PROJECT:  
**NEW O'REILLY AUTO PARTS STORE**  
**N. MARKSHEFFEL ROAD**  
**COLORADO SPRINGS, CO #11**  
**SITE DEMOLITION PLAN**

COMM #	4369
DATE:	10-11-19
REVISION DATE:

# SDP\_V1.pdf Markup Summary

**1 SITE DEMOLITION PLAN**

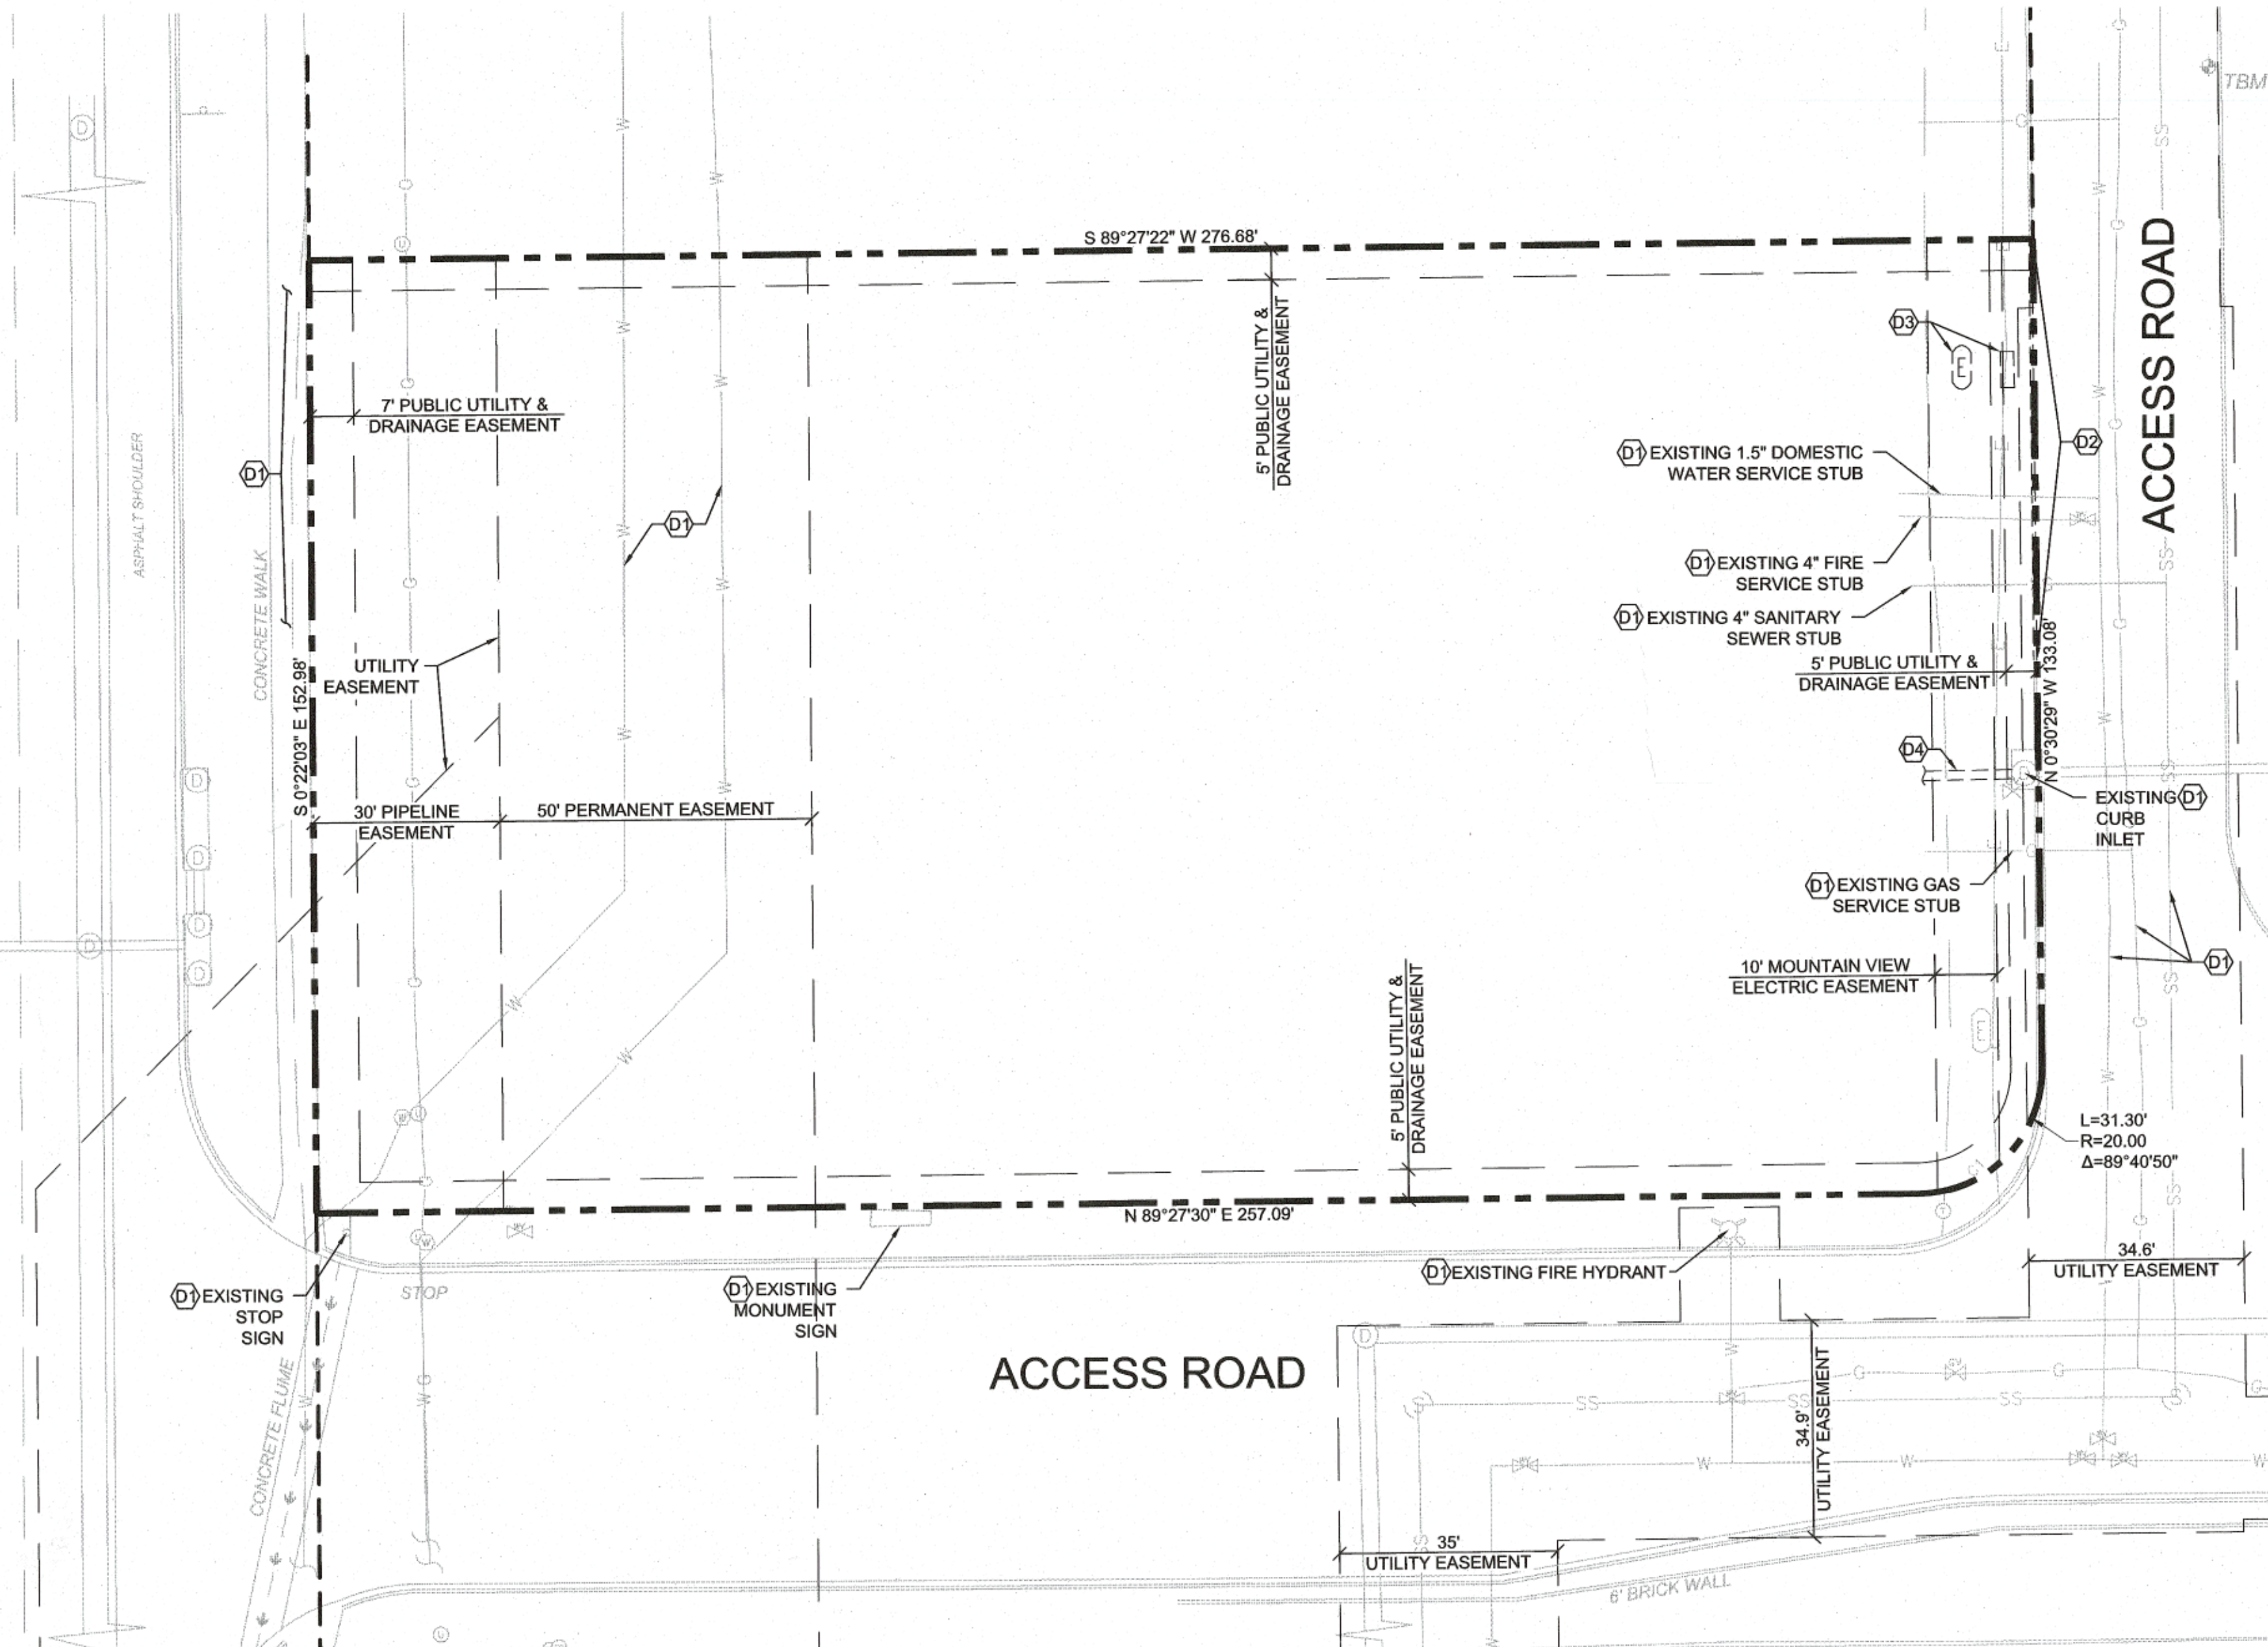
The following note should be added to all site development plans or non-residential site plans, as applicable, prior to PCD approval:

"The parties responsible for this plan have familiarized themselves with all current accessibility criteria and specifications and the proposed plan reflects all site elements required by the applicable ADA design standards and guidelines as published by the United States Department of Justice. Approval of this plan by El Paso County does not assure compliance with the ADA or any regulations or guidelines enacted or promulgated under or with respect to such laws."

Also required is an additional page illustrating the ADA route.

**Subject:** Text Box  
**Page Label:** 1  
**Lock:** Unlocked  
**Author:** dsdsevigny  
**Date:** 2/10/2020 9:07:52 AM  
**Status:**  
**Color:** ■  
**Layer:**  
**Space:**

The following note should be added to all site development plans or non-residential site plans, as applicable, prior to PCD approval:

“The parties responsible for this plan have familiarized themselves with all current accessibility criteria and specifications and the proposed plan reflects all site elements required by the applicable ADA design standards and guidelines as published by the United States Department of Justice. Approval of this plan by El Paso County does not assure compliance with the ADA or any regulations or guidelines enacted or promulgated under or with respect to such laws.”

Also required is an additional page illustrating the ADA route.

**Subject:** Text Box  
**Page Label:** 1  
**Lock:** Locked  
**Author:** dsdsevigny  
**Date:** 2/10/2020 9:10:12 AM  
**Status:**  
**Color:** ■  
**Layer:**  
**Space:**

add: PPR-20-002

**1 SITE DEVELOPMENT PLAN**

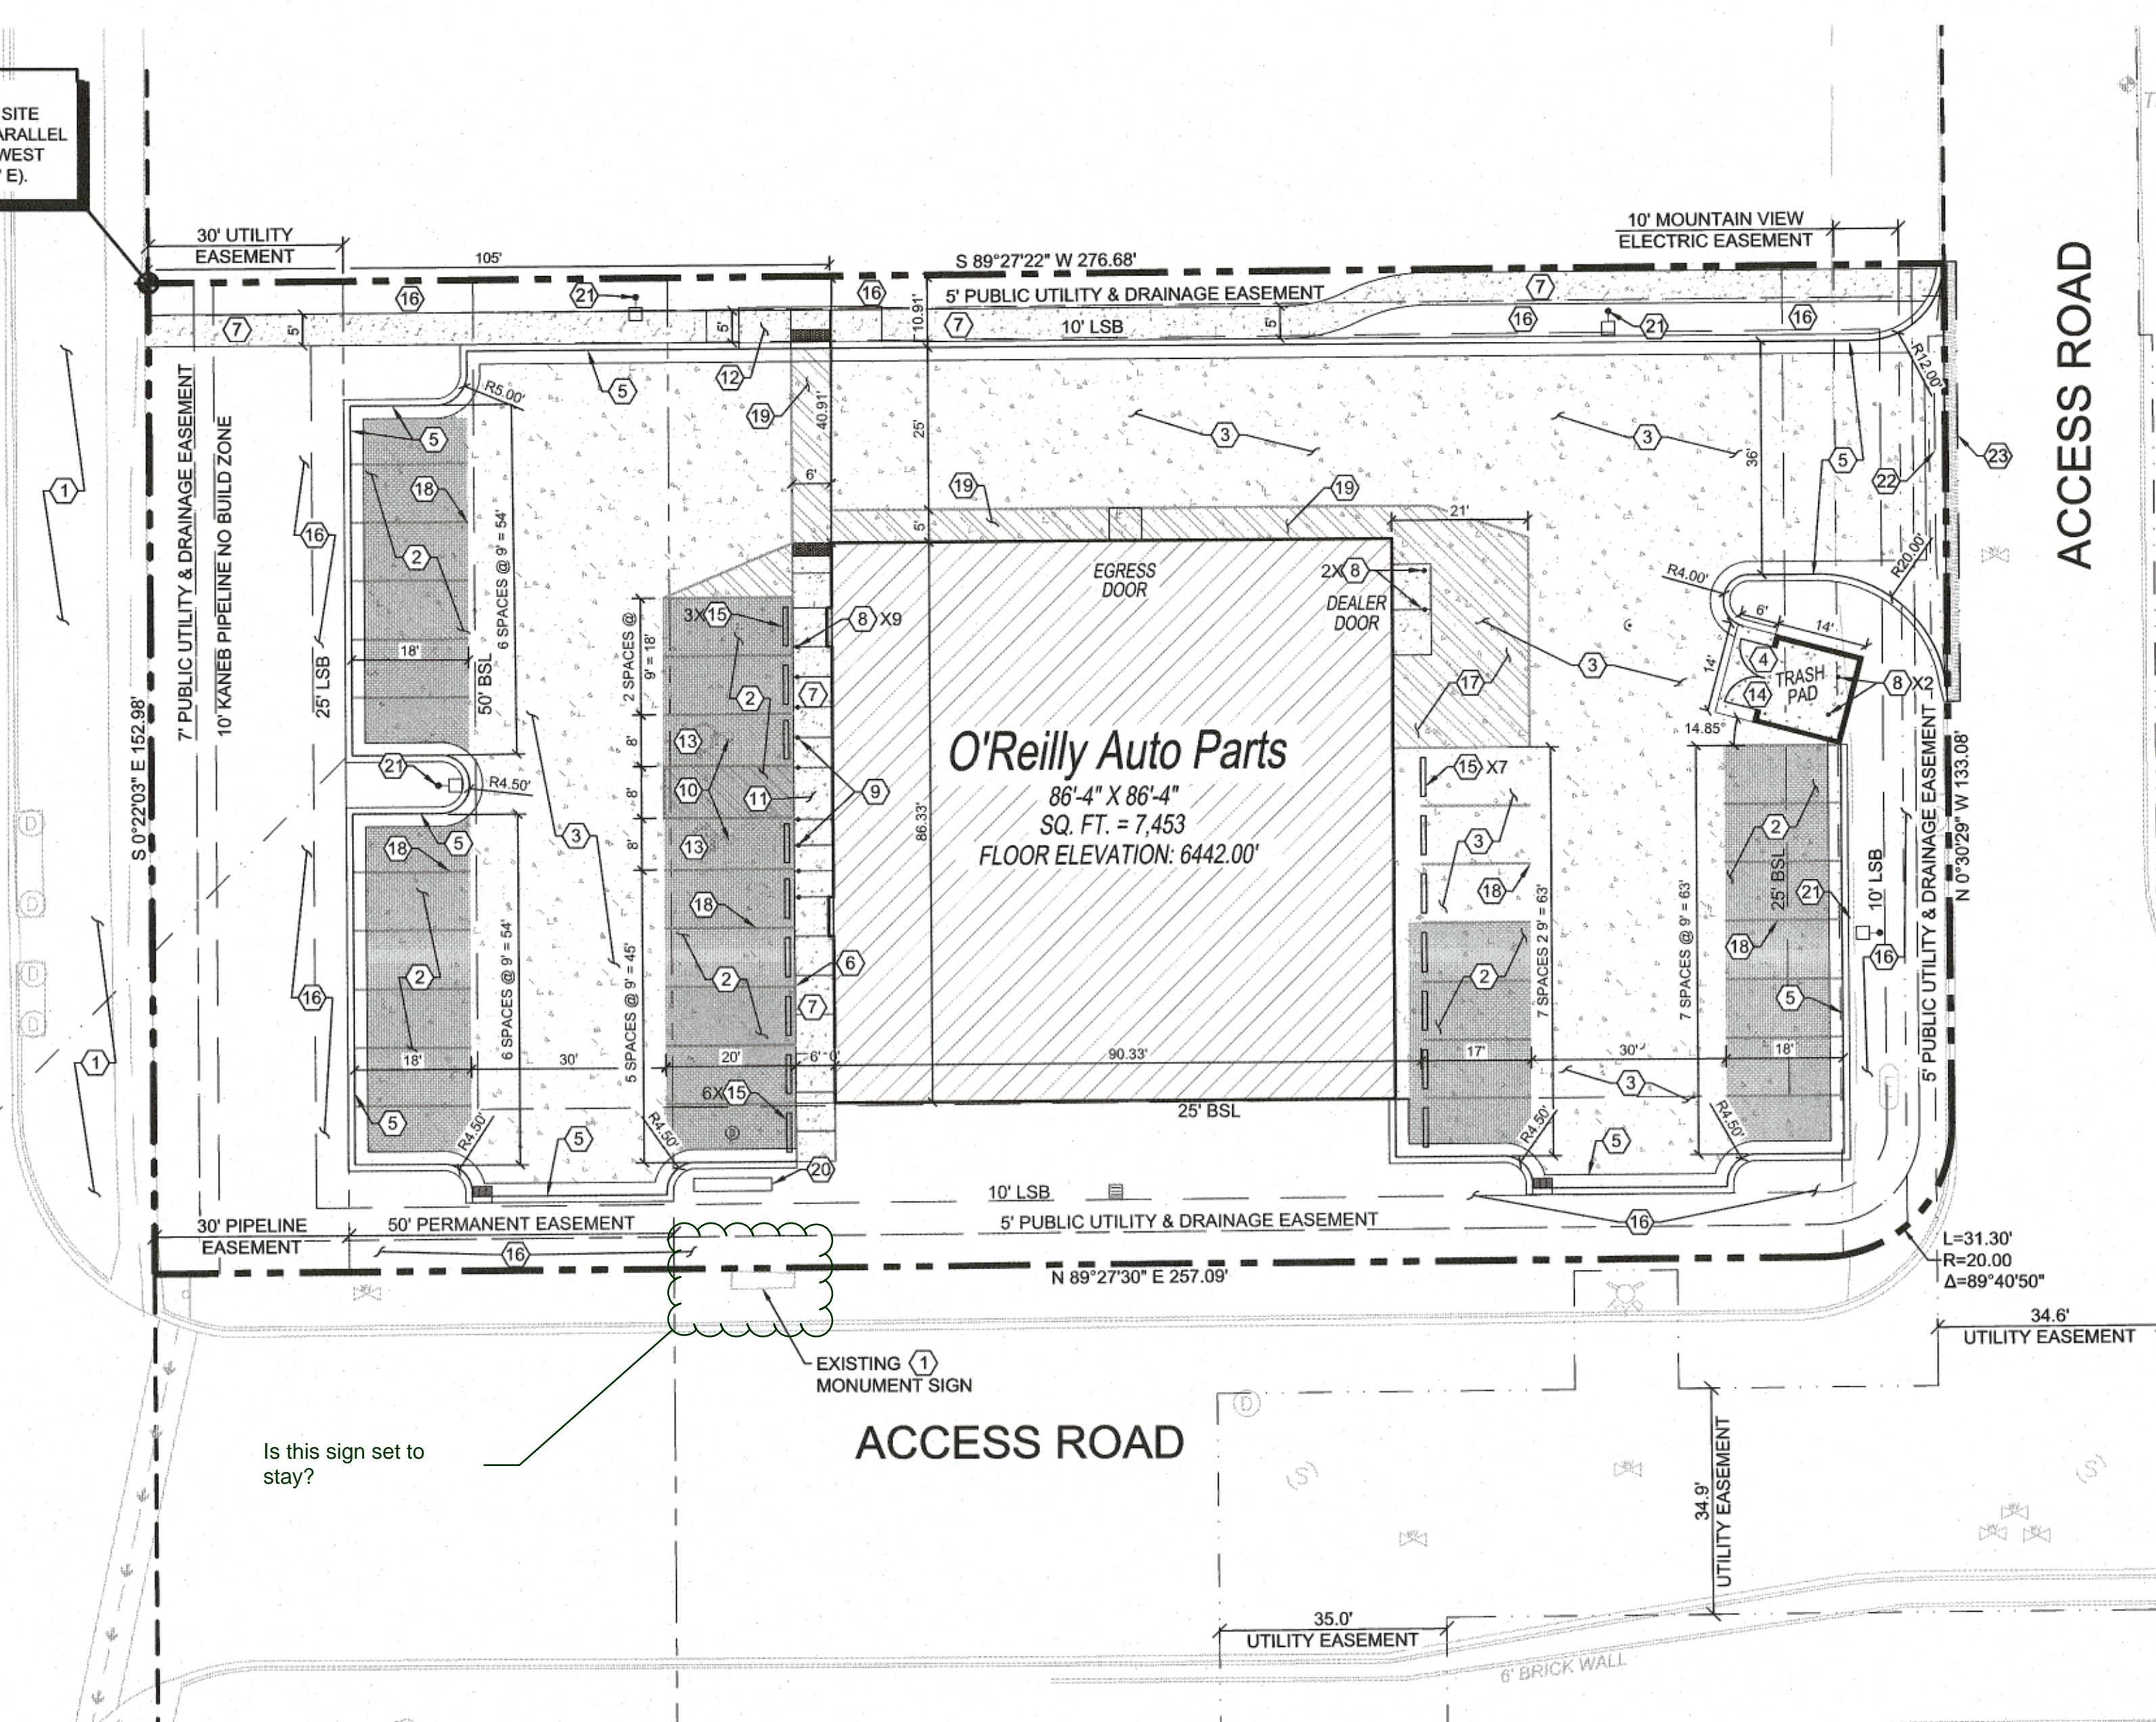
Bicycle Facilities required, see section 6.2.5.F

**Subject:** Cloud+  
**Page Label:** 2  
**Lock:** Locked  
**Author:** dsdsevigny  
**Date:** 2/10/2020 9:10:11 AM  
**Status:**  
**Color:** ■  
**Layer:**  
**Space:**

Is this sign set to stay?

**Subject:** Text Box  
**Page Label:** 2  
**Lock:** Locked  
**Author:** dsdsevigny  
**Date:** 2/10/2020 9:10:14 AM  
**Status:**  
**Color:** ■  
**Layer:**  
**Space:**

Bicycle Facilities required, see section 6.2.5.F
